VOLUME 2 OF 2 - ZONING

# Summary of Comments on P:\Projects\1216-00\BIM\Revit \Families\TITLEBLOCKS\EXTELL Proposal\_atwalj.pdf

Summary of Comments on FP-401.00

## Summary of Comments on AAI-TWR-ARCHITECTURE- CANTILEVER\_namrudl.rvt

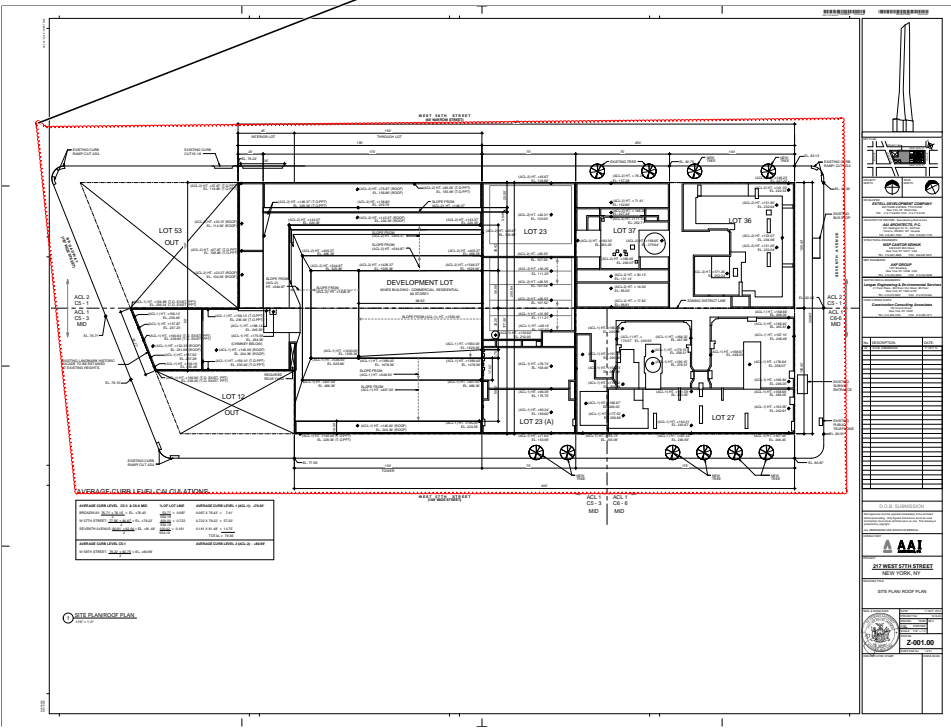
Verify compliance with street tree planting for the entire zoning lot street frontage as per ZR 33-03. Provide ST-1

Provide records to verify proof of existing conditions shown on plans provided, approved drawings of existing building floor area zoning calculation to ensure that the proposed zoning analysis does not exceed the maximum permitted

Verification of existing mechanical deductions is required. Sufficient proof must be provided for entire the deducted floor area. (Dimensions) and provide layout of heavy equipment for each floor in consideration to qualify for deductions.

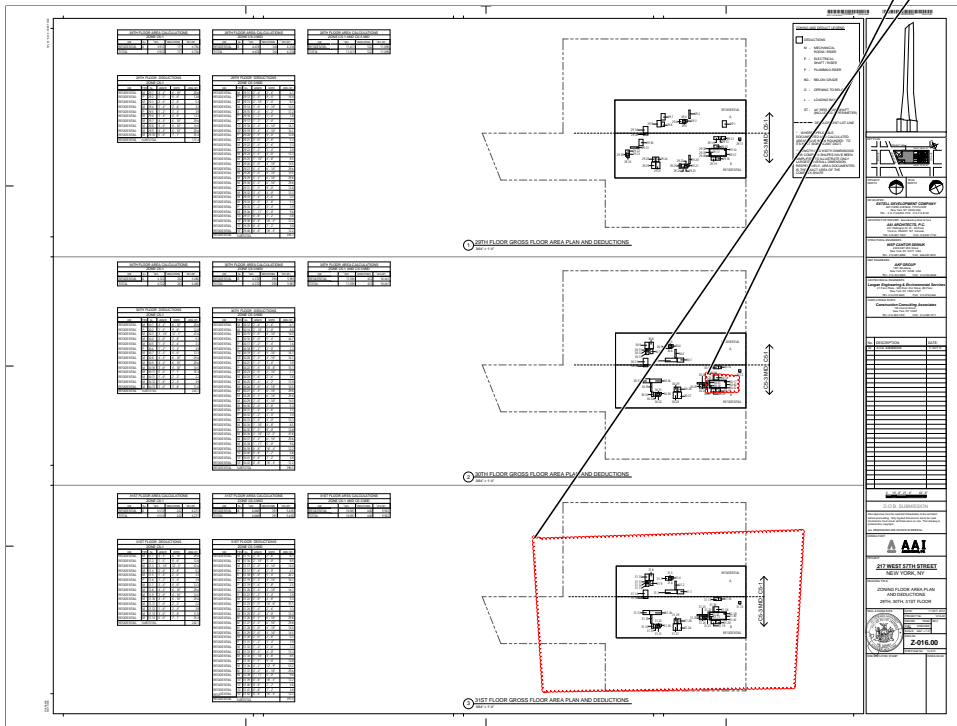
Please clarify deductions taken within stair inclosure. **TYP all floors**  
8" for the stair perimeter, not sure what the additional 60+ sq. ft. is for per floor. ARCH/MH dwgs does not indicate any shaft enclosures within stair.

Mech. plan was not provided for this floor. 31st FL.

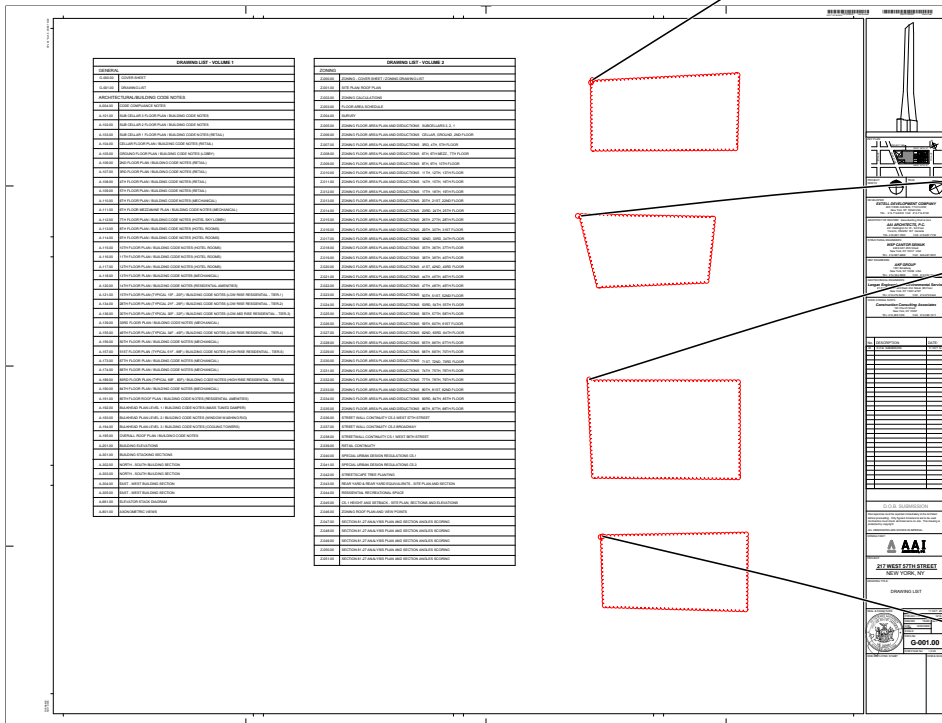
NYC ENERGY CODE 2011  
BC 1301 Provide data sheet and state on plans, full compliance with NYC energy code.

List all progress inspections for energy code compliance on drawing.

Supporting documentation: building wall sections fail to detail insulation as continuous and/or cavity insulation to match the location and R value in the energy analysis.

Supporting documentation: door, window and skylight schedules fail to provide columns for u values for each exterior door, window and skylight type. If door, window and skylight types are drawn instead, with specifications included next to the respective drawing, u and SHGC values must appear with the other performance specifications for clarity and ease of contractor take-offs.

Supporting documentation: heating and cooling systems, including controls, are not provided such that they match the systems, equipment and performance criteria in the energy analysis.

Supporting documentation: plans fail to include reflected ceiling plans or lighting layouts on floor plans with fixture types and quantities, lamp wattages and quantities, space areas, sensors and controls to match those in the energy analysis for each room in the building.

Supporting Documentation: Building wall sections fail to label insulation at the roof/ceiling, wall and/or at the foundation, slab-on grade, basement or cellar with R values matching those in the Energy Analysis.

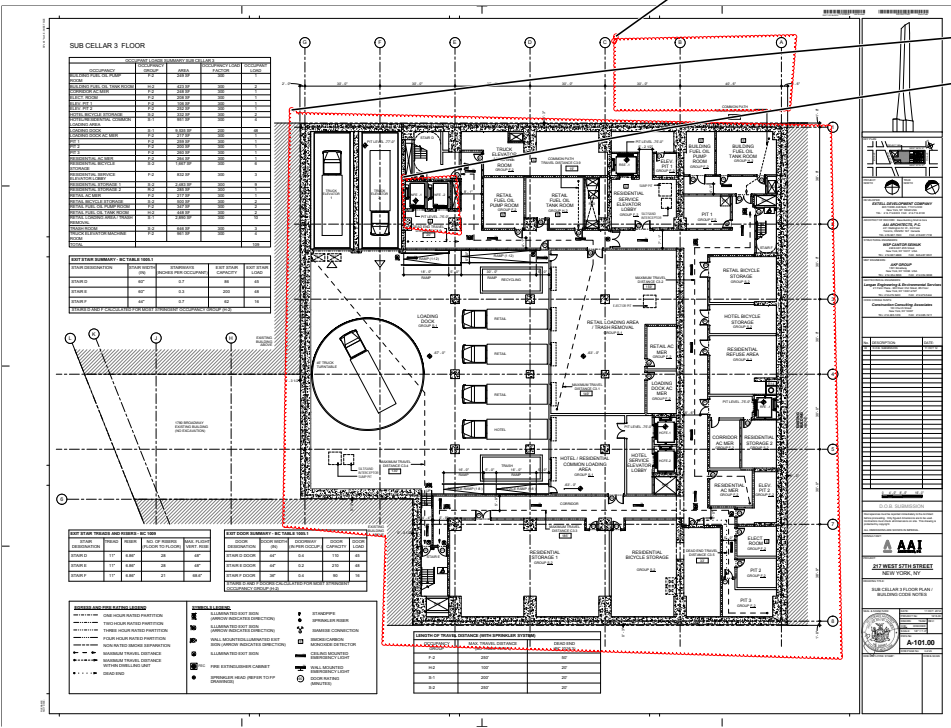
Indicate on drawings fire ratings for all proposed partitions /interior sections and details for verification purposes construction. Indicate construction materials and fire rating of construction elements of building to verify compliance with requirements of Table 601 class I-B structure.

BC 1213  
BC 1207.3.1  
BC 707.13

BC 903.2.10 Trash compactor is required for building which contains more than 12 units.

- Indicate trash compactor size, dimensions, & location.
- Indicate clearance around trash compactor
- Indicate sprinkler locations in the trash compactor room.
- Indicate ventilation to fresh air at trash compactor room
- provide floor drain at trash compactor room
- Indicate a minimum, 3 hr fire rated enclosure (walls) at trash compactor room i, including 1 1/2hr FPSC rated door.
- Indicate construction details and materials at trash compactor room
- Indicate sound transmission class (stc) ratings for all trash compactor walls and trash chute walls and disposal; room walls.

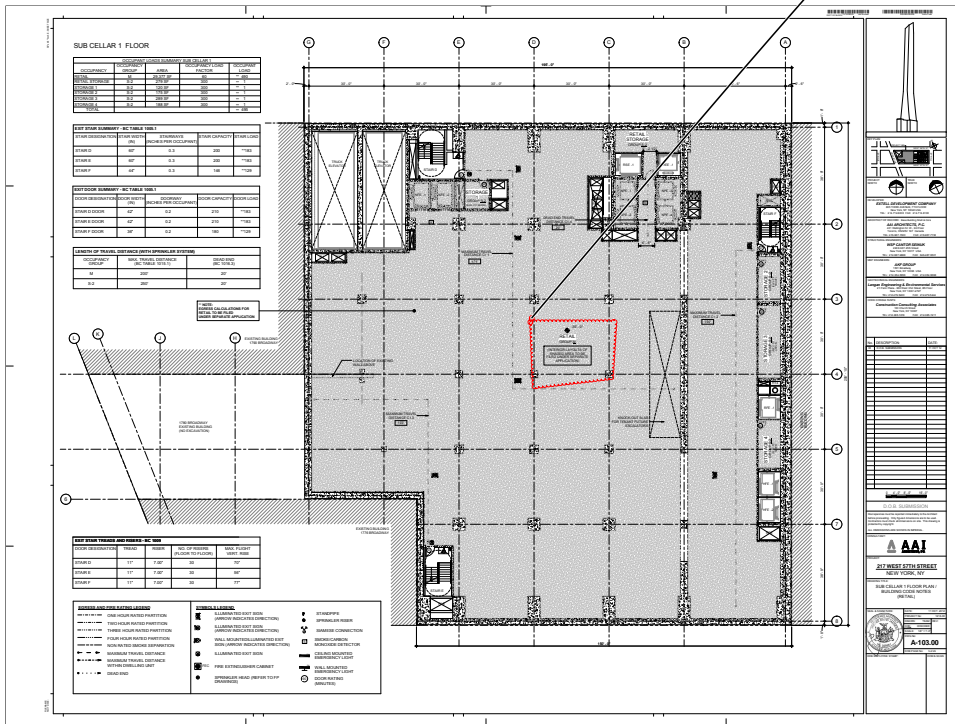
All nonresidential facilities to comply with BC 1109.

Water closets

Lavatories

Show all grab-bars including vertical

Required clearance around the water closet to comply with ICC/ANSI 2003 604.3

TABLE 403.1 Provide table for plumbing fixtures to comply with table. 403.1. Provide calculations within each space, etc. and show layout to verify compliance to BC 1101.2; ICC/ANSI A117.1-2003

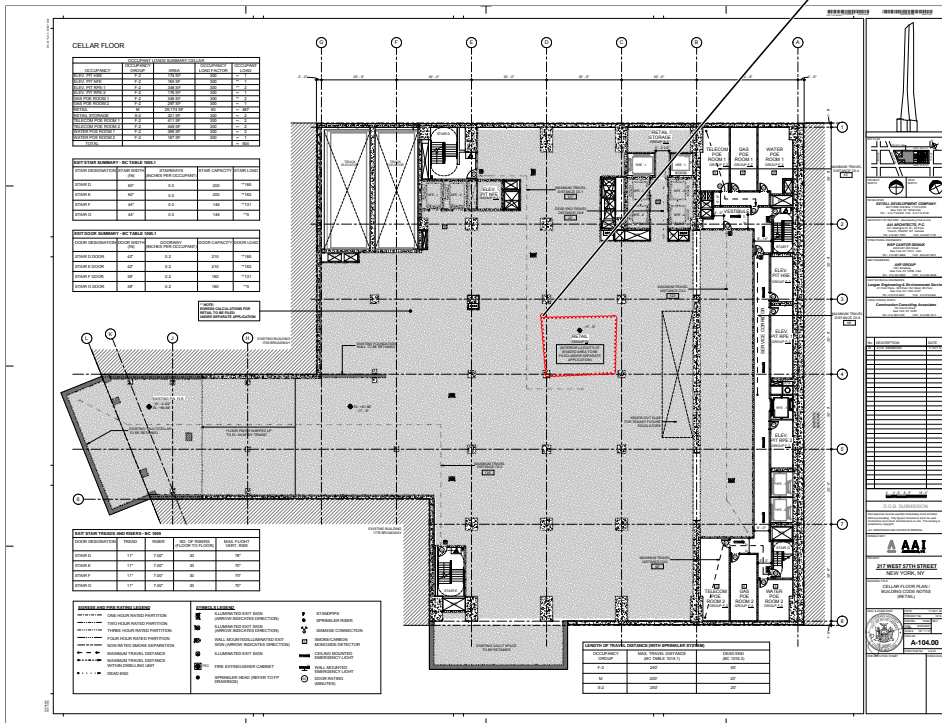
All nonresidential facilities to comply with BC 1109.

Water closets

### Lavatories

Show all grab-bars including vertical

Required clearance around the water closet ~~to~~ comply with ICC/ANSI 2003 604.3

BC 1910, LL 17/95 **Earthquake**  
state on plan and show compliance with LL 17/95;  
separation (1" per 50 ft. height); (compliance must be verified on A & ST floor plans)  
earthquake code applicability & pounding notes;

Author: dtitus Subject: Polygon Date: 1/7/2013 9:28:30 AM  
Elevator to accommodate 24"x76" ambulance stretcher (BC 3002.4).

Author: dtitus Subject: Polygon Date: 1/7/2013 9:35:40 AM  
TABLE 403.1 Provide table for plumbing fixtures to comply with table. 403.1. Provide calculations within each space, etc. and show layout to verify compliance to BC 1101.2; ICC/ANSI A117.1-2003

All nonresidential facilities to comply with BC 1109.  
Water closets  
Lavatories  
Show all grab-bars including vertical  
Required clearance around the water closet to comply with ICC/ANSI 2003 604.3

Provide exit lighting and directional signs (lighting) & (egress) as per BC 1006, BC 1011, BC 1026 (both EG and Construction plans)

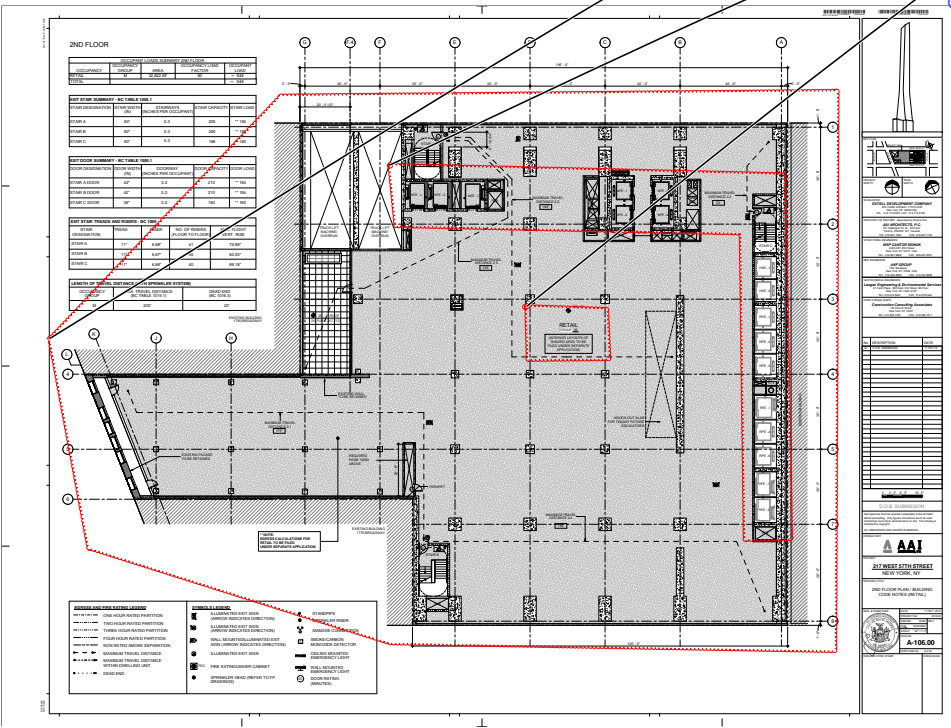
TABLE 403.1 Provide table for plumbing fixtures to comply with table. 403.1. Provide calculations within each space, etc. and show layout to verify compliance to BC 1101.2; ICC/ANSI A117.1-2003

All nonresidential facilities to comply with BC 1109.

Water closets

Lavatories

Show all grab-bars including vertical

Required clearance around the water closet to comply with ICC/ANSI 2003 604.3

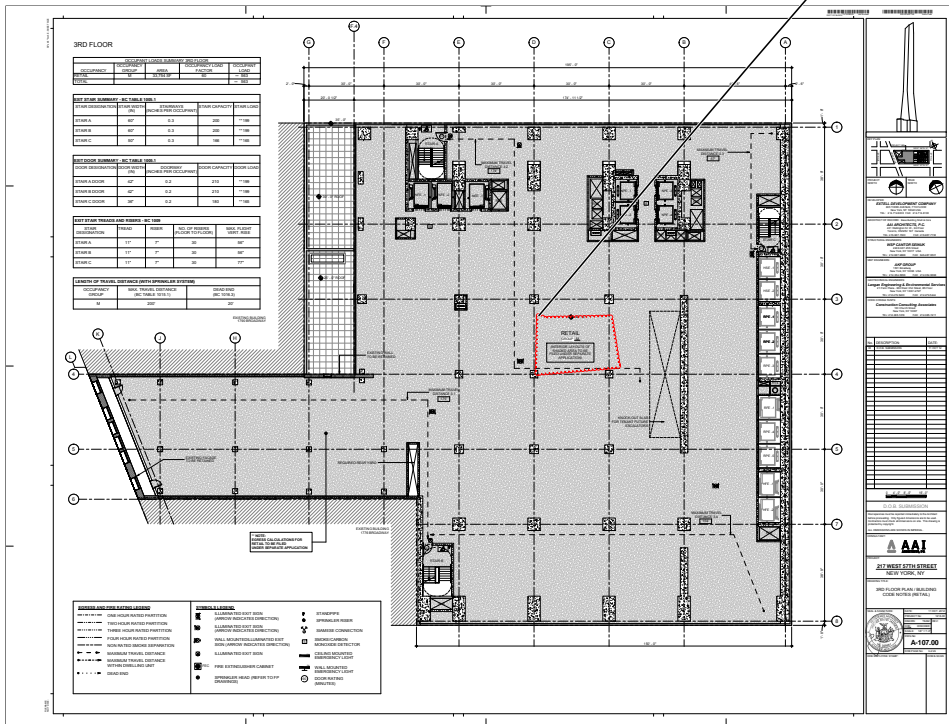
TABLE 403.1 Provide table for plumbing fixtures to comply with table 403.1. Provide calculations within each space, etc. and show layout to verify compliance to BC 1101.2; ICC/ANSI A117.1-2003

All nonresidential facilities to comply with BC 1109.

### Water closets

Lavatories

Show all grab-bars including vertical

Required clearance around the water closet to comply with ICC/ANSI 2003 604.3

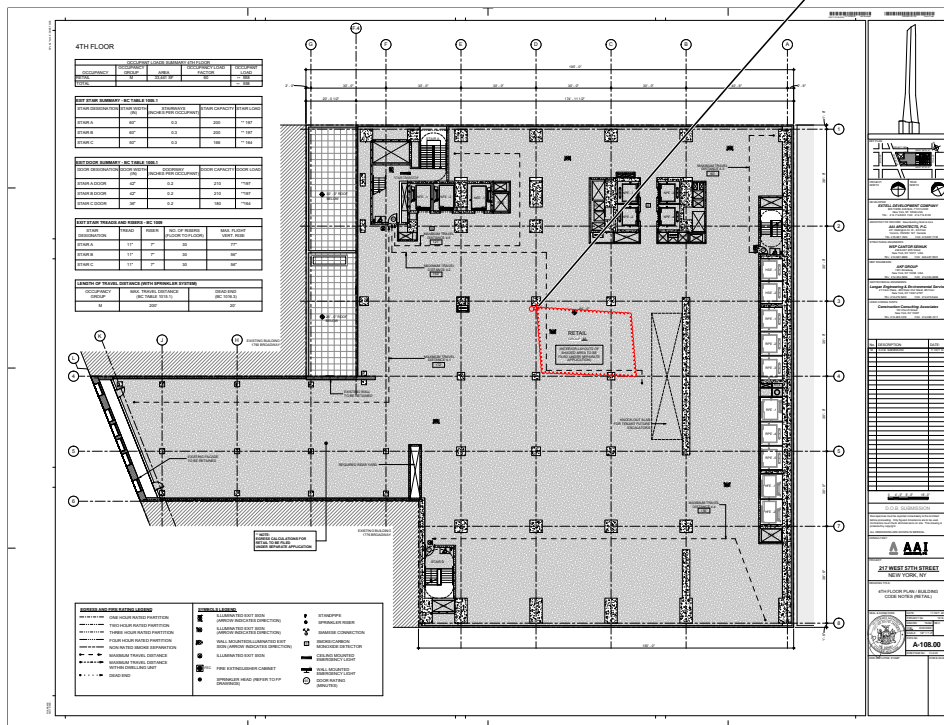
TABLE 403.1 Provide table for plumbing fixtures to comply with table 403.1. Provide calculations within each space, etc. and show layout to verify compliance to BC 1101.2; ICC/ANSI A117.1-2003

All nonresidential facilities to comply with BC 1109.

### Water closets

Lavatories

Show all grab-bars including vertical

Required clearance around the water closet to comply with ICC/ANSI 2003 604.3

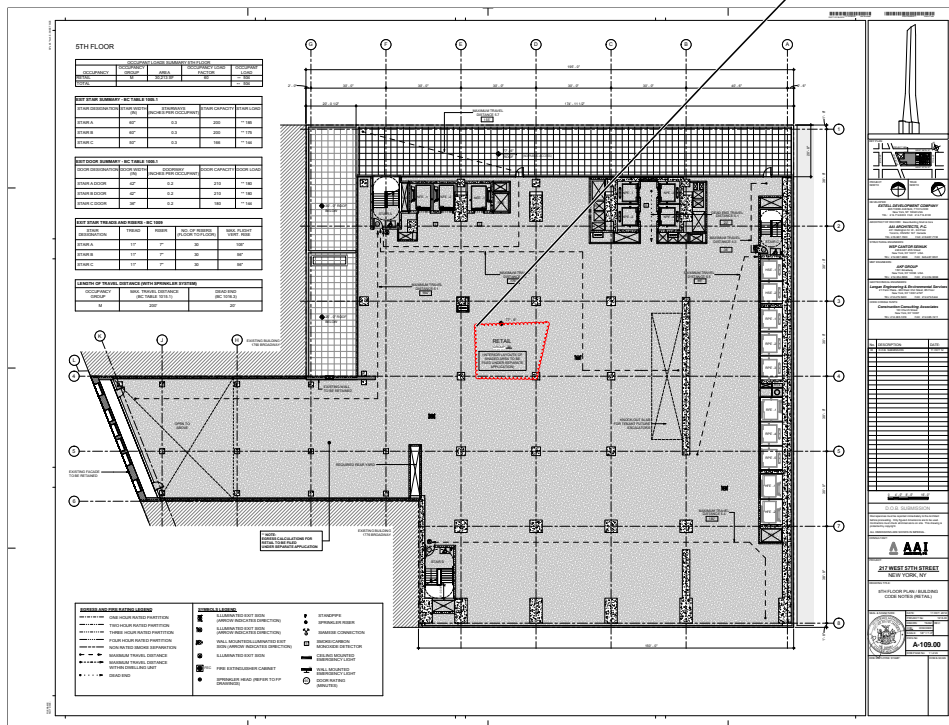
TABLE 403.1 Provide table for plumbing fixtures to comply with table. 403.1. Provide calculations within each space, etc. and show layout to verify compliance to BC 1101.2; ICC/ANSI A117.1-2003

All nonresidential facilities to comply with BC 1109.

Water closets

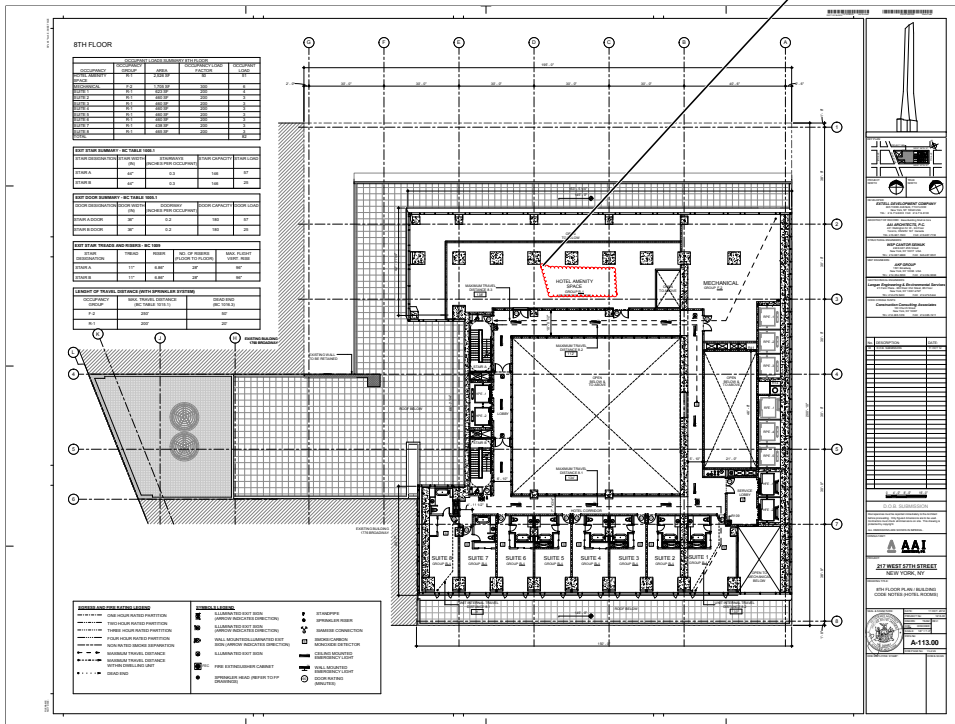
Lavatories

Show all grab-bars including vertical

Required clearance around the water closet to comply with ICC/ANSI 2003 604.3

Provide exit lighting and directional signs (lighting) & (egress) as per BC 1006, BC 1011, BC 1026 (both EG and Construction plans)

The common path of egress travel shall not exceed 125 feet as per BC 1013.3. The maximum length of exit access travel, measured from the most remote point within a story/space to the entrance to an exit along the natural and unobstructed path of egress travel, shall not exceed the distances given in BC Table 1015.1.

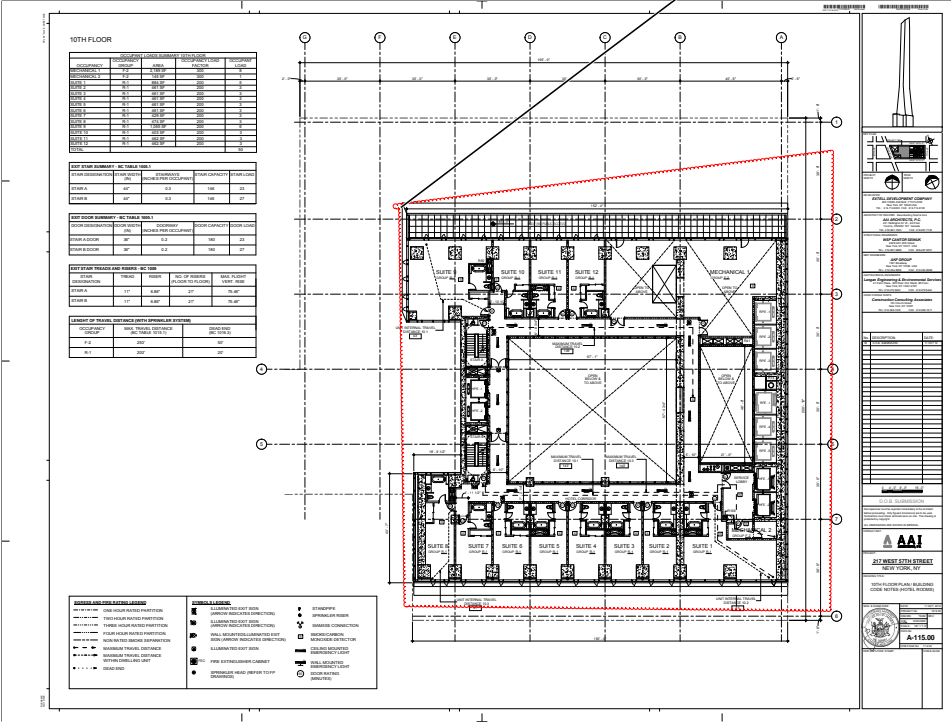
- Provide note describing stairway door operation and stairway communications system as per BC 403.12 04-16-13
- Provide note describing smoke proof exit enclosures for compliance with BC 403.13. 04-16-13
- Provide note describing impact-resistant stairs enclosures as per BC 403.15 04-16-13
- Indicate photo luminescent exit path markings as per BC 403.16. 04-16-13
- Provide exit lighting and directional signs (lighting) & (egress) as per BC 1006, BC 1011, BC 1026 (both EG and Construction plans) 04-16-13

- Group R-1 occupancies shall be provided with accessible features in accordance with Sections 1107.6.1.1 through 1107.6.1.3.
- Show all grab-bars including vertical as per P102.8.3.1, (TYP)
- Provide note within each accessible unit or sleeping unit shall comply with the 2008 code and Chapter 1 through Chapter 10 of ICC A117.1. (TYP) 04-16-13
